Our Ref: MC0789 LB RH17 SW FW DOC

RE: DM/26/1224 – Gilridge, Brighton Road, Handcross, West Sussex, RH17 6BZ

Drainage Condition (5)

APPENDIX II Proposed Drainage Layout

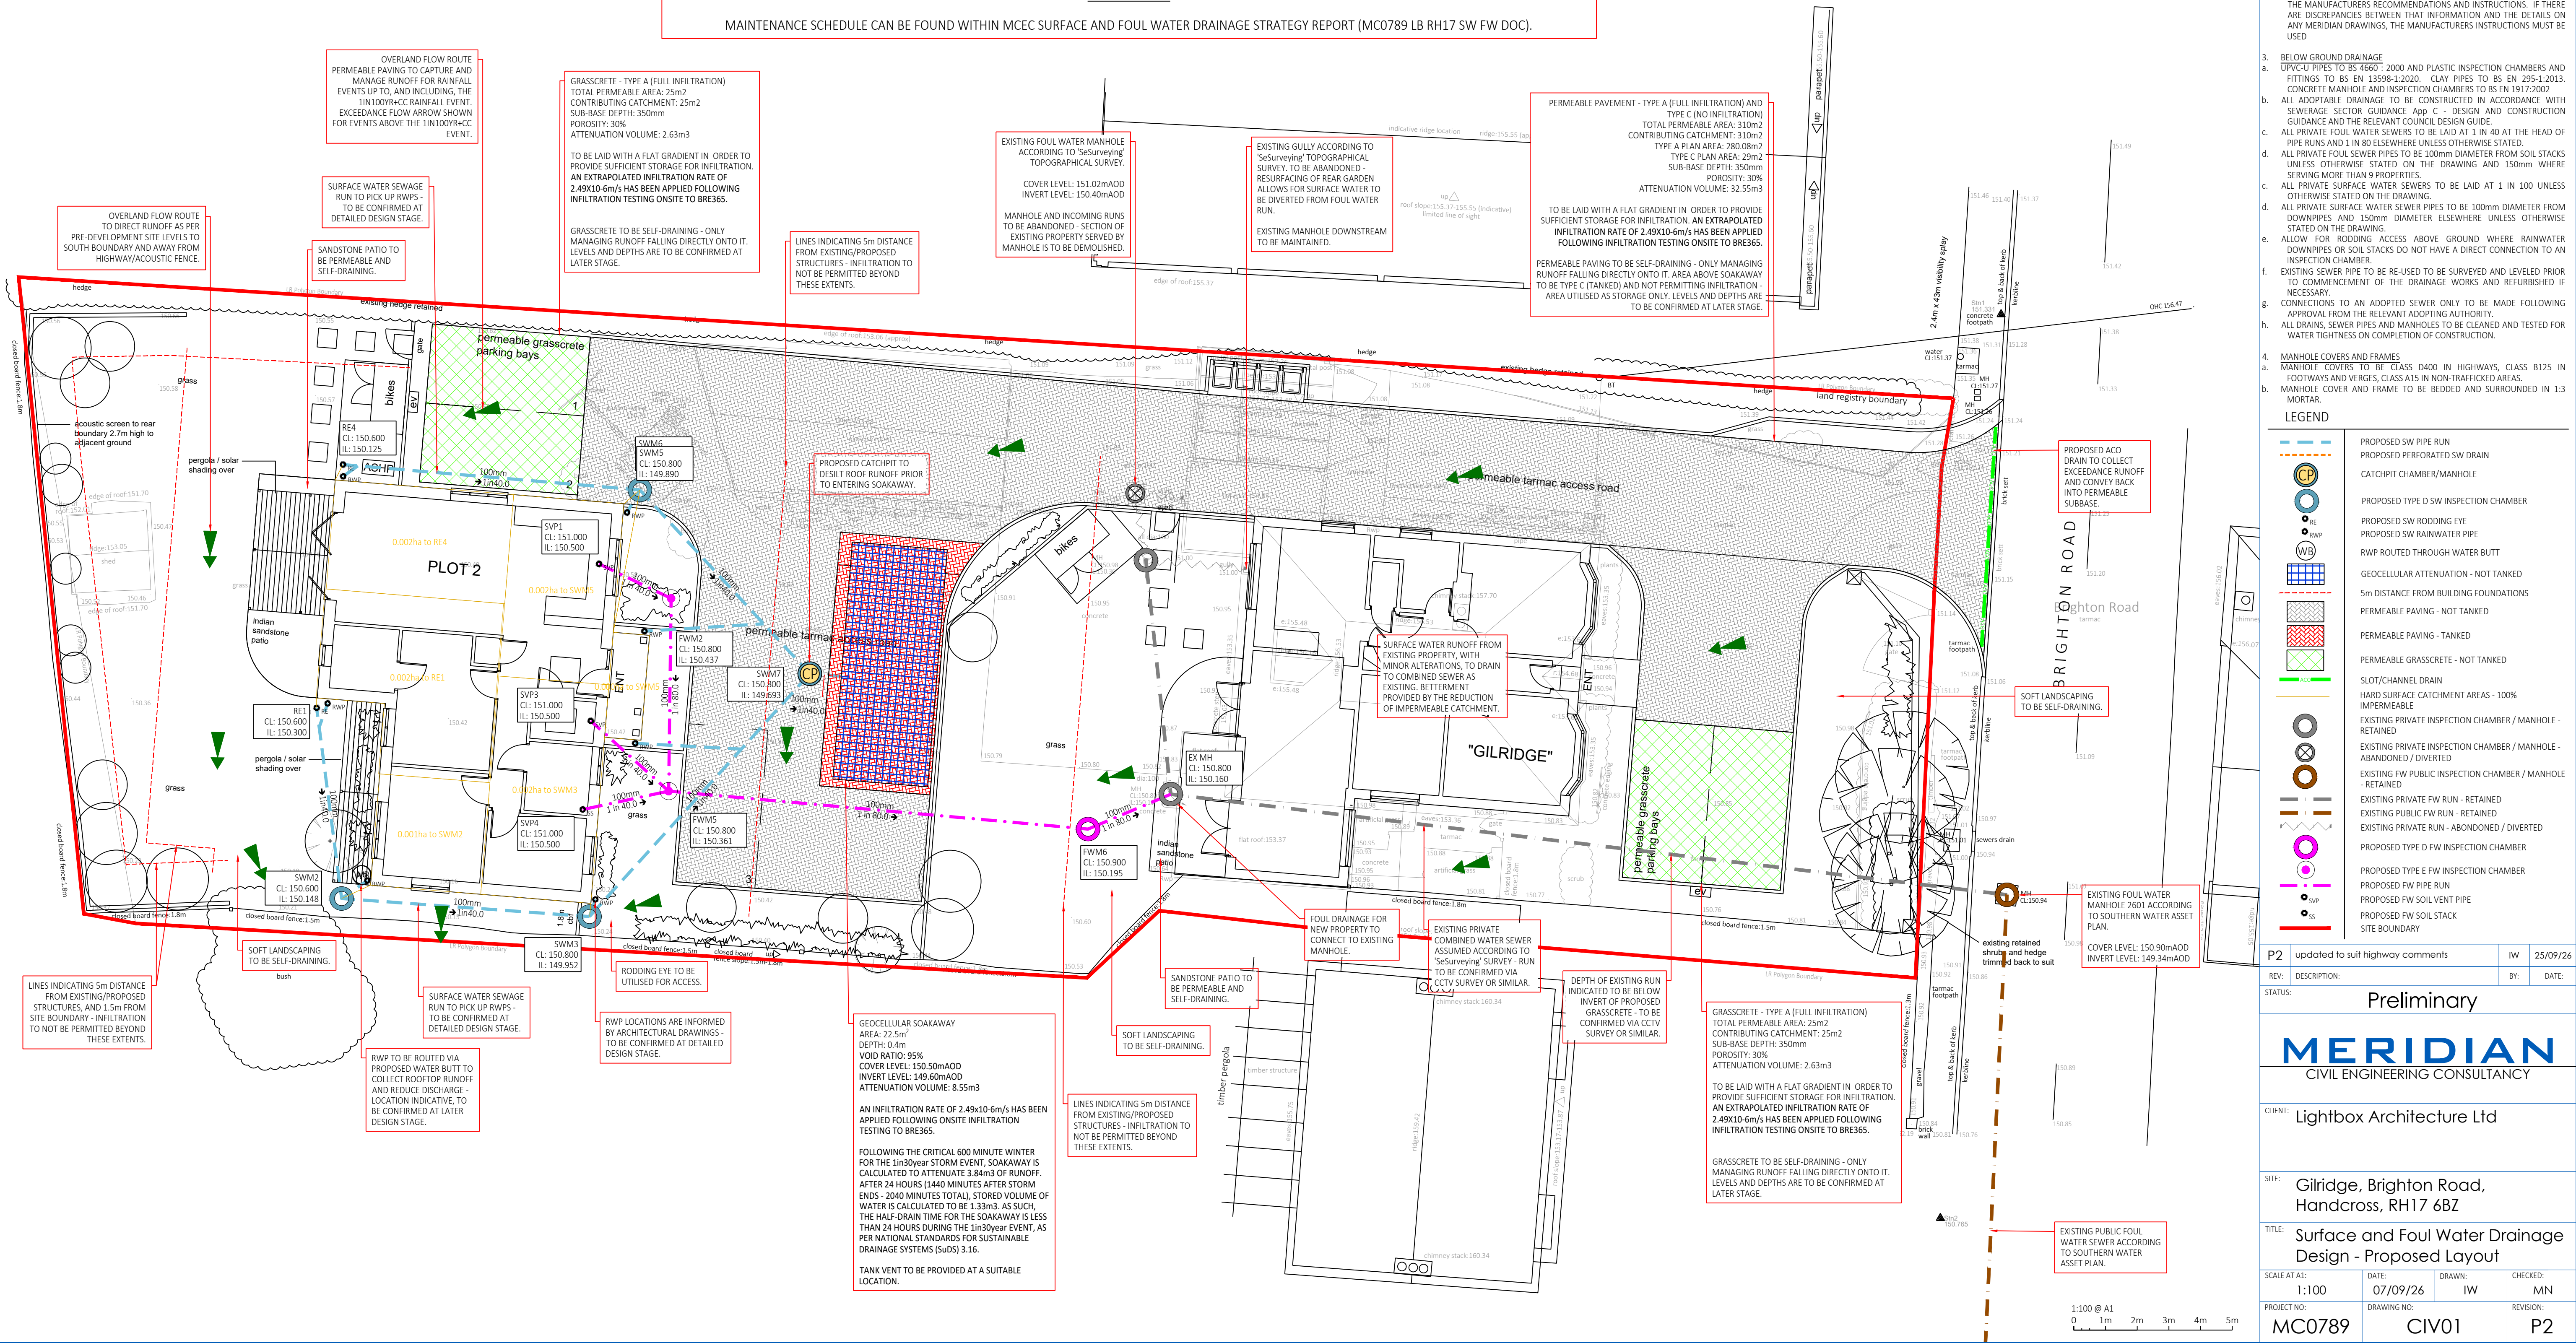
In regard to Condition 7 (exceedance flow route plan), National Highways stated the following:

The cross-section drawings should therefore be revised to clearly show the soakaway structure, finished ground levels, verge top level and separation distances from the SRN boundary. The submission should also demonstrate that the proposed soakaway will not adversely affect the stability of the adjacent sloping ground (part of the SRN).

Following Condition 7 requirements, exceedance flow arrows and overland flow routes have been included on the updated drainage layout (CIV01 – P2). Pre-development site levels show a low point on the southern boundary and overland flow, in exceedance events, can be directed to this low point, as per the existing situation, away from the highway and acoustic fence constraints. A proposed ACO drain is also to collect exceedance runoff and convey it back into the permeable sub-base. It should be noted the drainage design is to accommodate rainfall from the site for events up to, and including, the 1 in 100 year + 45% climate change event.

In line with Condition 8 requirements, the drainage strategy has been revised so that the soakaway is no longer located in the rear garden of the proposed property, but rather beneath the driveway to the front of it. The existing front property is to drain as existing with betterment provided by a reduction in contributing impermeable catchment. Proposed driveways

SOAKAWAY DETAIL

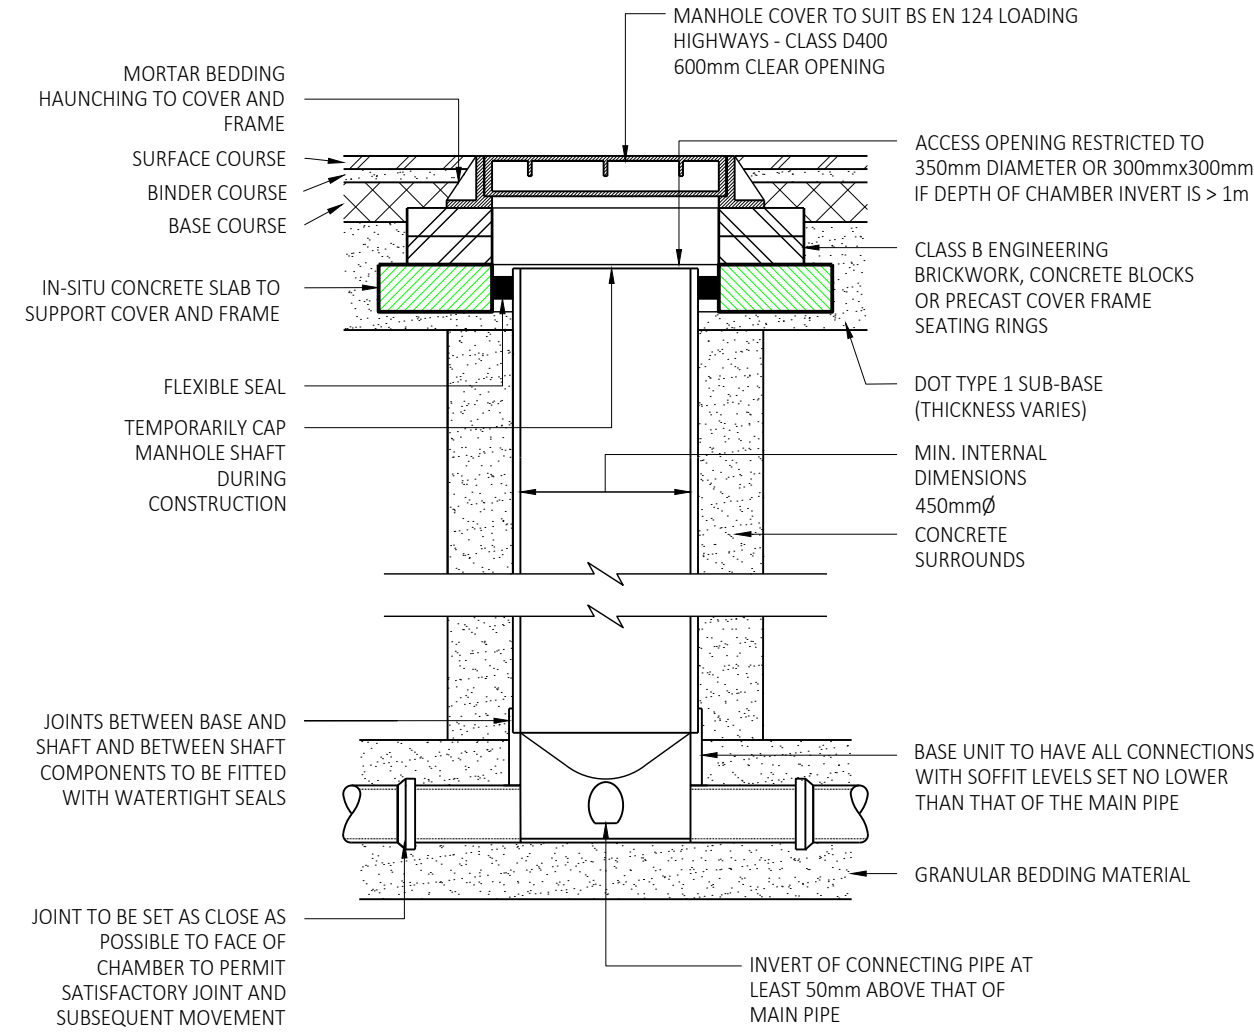
In addition, the cross-sections need to be revised to provide sufficient detail to demonstrate geotechnical risk of the acoustic barrier, including its foundations, is managed in compliance with the Design Manual for Roads and Bridges (DMRB) CD 622. It is in the interest of the safety of the SRN to demonstrate the structural integrity of the acoustic barrier because it would be located adjacent to the SRN boundary at the top of the embankment for the A23.”

Based on this rate, roof runoff from the new dwelling drains via a catchpit to a geocellular soakaway beneath the front driveway (22.5m², 0.4m deep, 8.55m³ of storage), which was relocated in the latest revision following the Highway Authority's concerns regarding the western embankment. This has been sized for the 1 in 100 year + 45% climate change event and half-drains within 24 hours for the 1 in 30 year event (3.84m³ reducing to 1.33m³ after 24 hours). The access road and parking areas are to be permeable and self-draining (providing 32.55m³ and 2 x 2.63m³ of storage respectively). No infiltration (other than self-draining) is proposed within 5m of structures or 2.5m of the site boundary. The existing Gilridge roof is to continue draining as existing. It can be seen the proposed soakaway is sited as close to the test pit depth as practical.

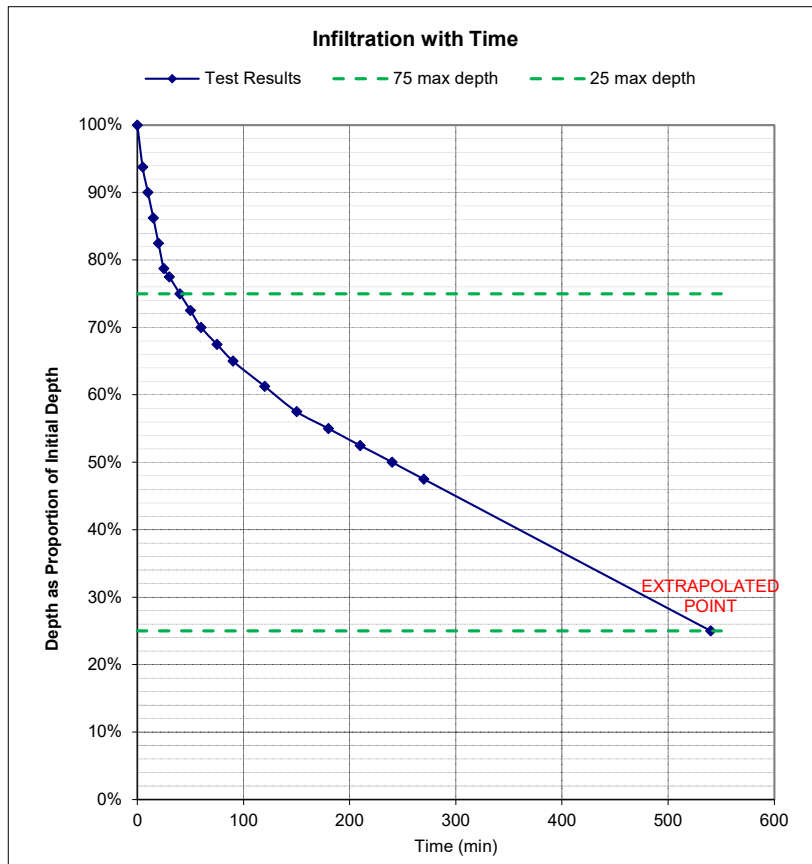
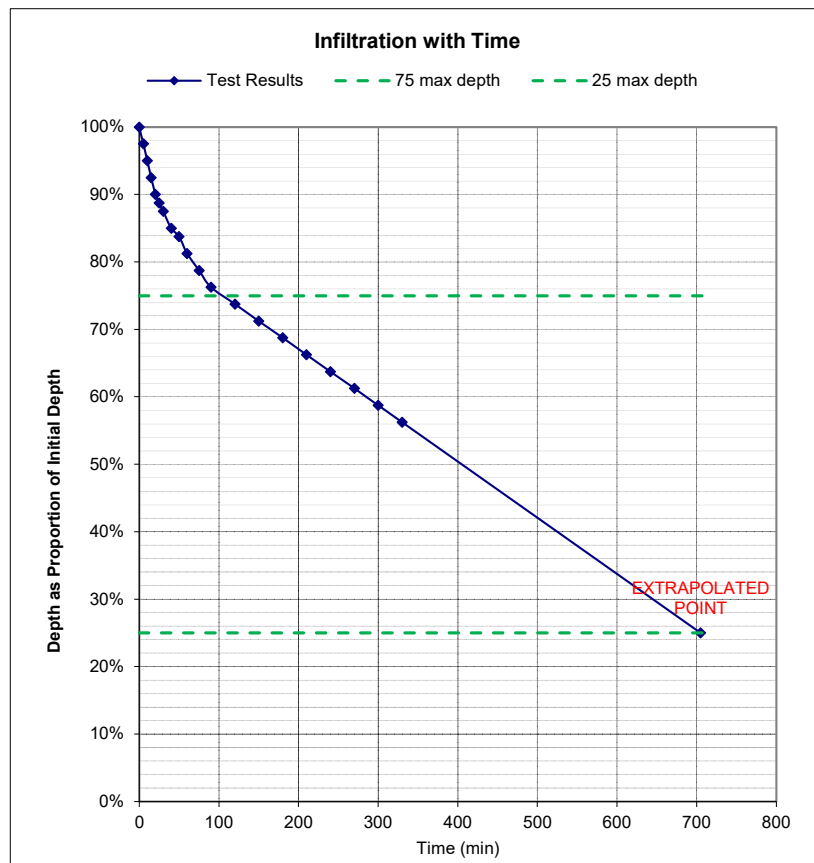
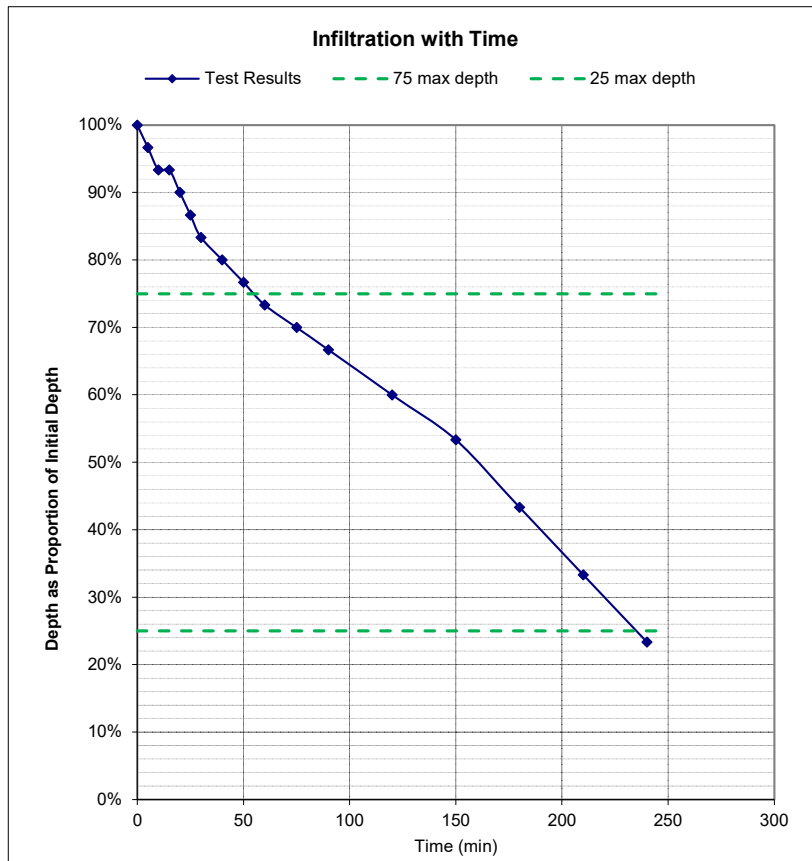
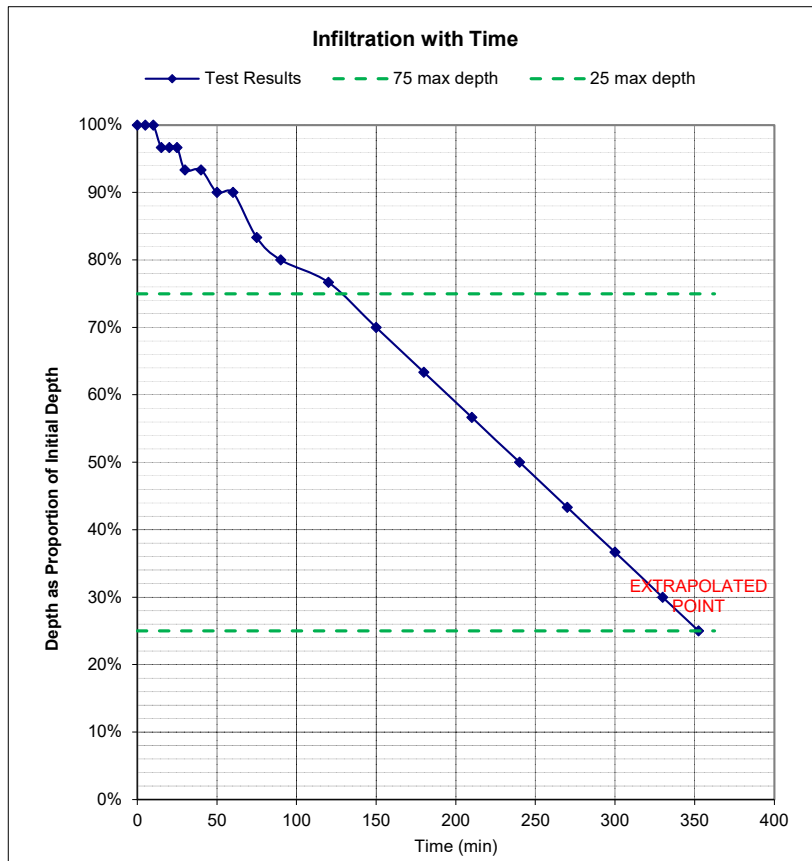
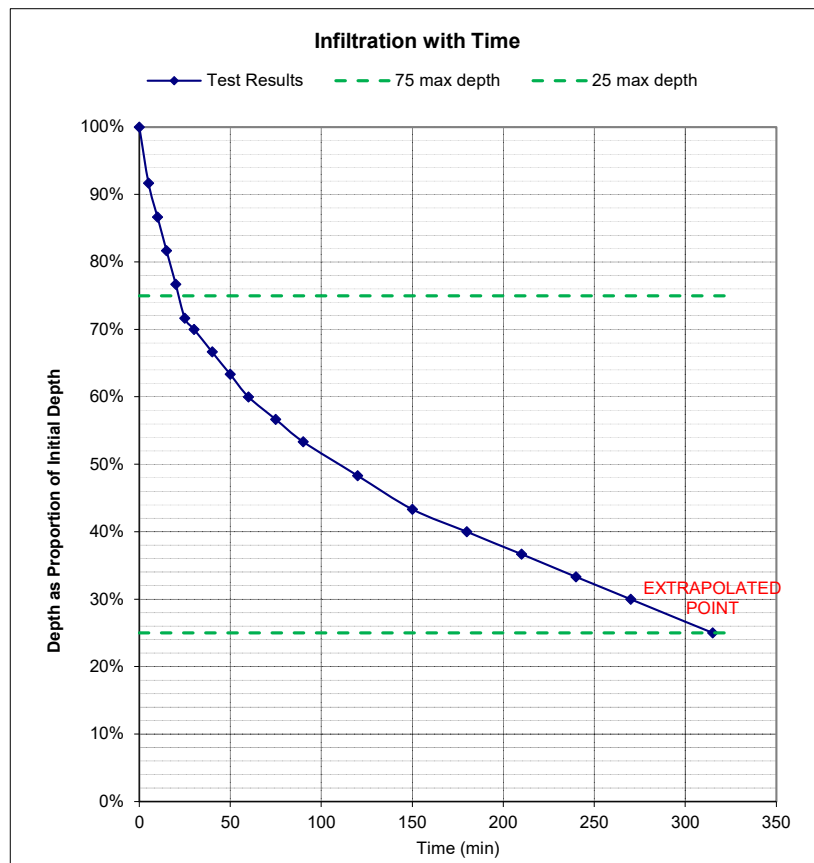
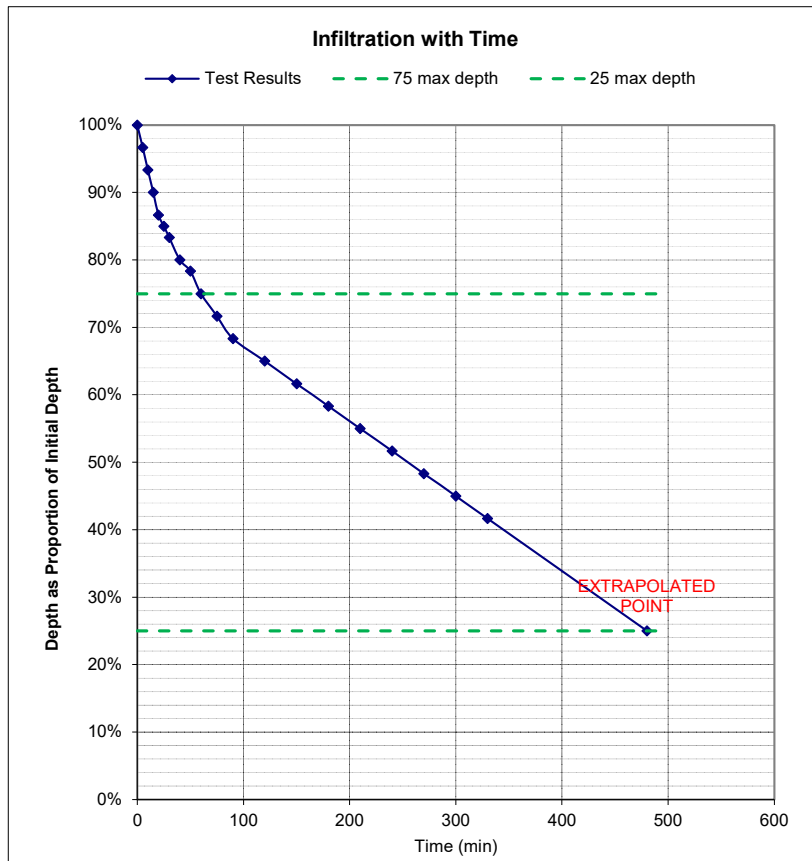
In respect of Condition 5, it is understood that this primarily relates to the infiltration testing undertaken by CSSI not being fully compliant with BRE365, and the subsequent rates being extrapolated. Please find enclosed the latest revision of our drainage strategy (MC0789 LB RH17 SW FW DOC – P2), drainage layout (CIV01 – P2) and construction details (CIV02 – P2). Our response in respect of the Highways Conditions (7 and 8) is set out in the section below.

As per the comments, the testing undertaken is not fully compliant for two main reasons – the tests were not completed three times in each pit (only two full tests were undertaken), and not all of the tests reached the 25% water level. In addition, the deeper pit (TP01, dug to 1.2m) showed signs of collapse during the first test, which raised the base of the pit by approximately 200mm, giving an effective depth of 1.0m. TP02 was dug to 0.5m.

As shown above, the shortfalls are fairly small (15mm in TP02, and 30mm and 100mm in TP01) and in all cases the water level fell consistently and almost linearly. Looking at the TP01 interpretation graph, the last 4-5 readings are consistent in drop, and the early readings of the third tests in both pits are in keeping with the previous tests. As such, we believe the extrapolated rates to be representative. It should also be noted that TP02 Test 1 was fully compliant, returning a rate of $6.04 \times 10^{-6} \text{ m/s}$.

This is supported by the geology encountered, which was topsoil over a sand/clay mix, underlain by clean sand to the base of both pits – in keeping with the Upper Tunbridge Wells Sand Formation shown on BGS mapping. We have attached the revised interpretation for TP01 using the 1.0m effective depth.

For the purposes of the calculations, we have used the slowest rate from all of the tests ($2.49 \times 10^{-6} \text{ m/s}$, TP01 Test 2). This rate was derived using the original 1.2m depth – re-interpreting TP01 at 1.0m actually increases the rate slightly, as such the design rate utilised is on the conservative side.
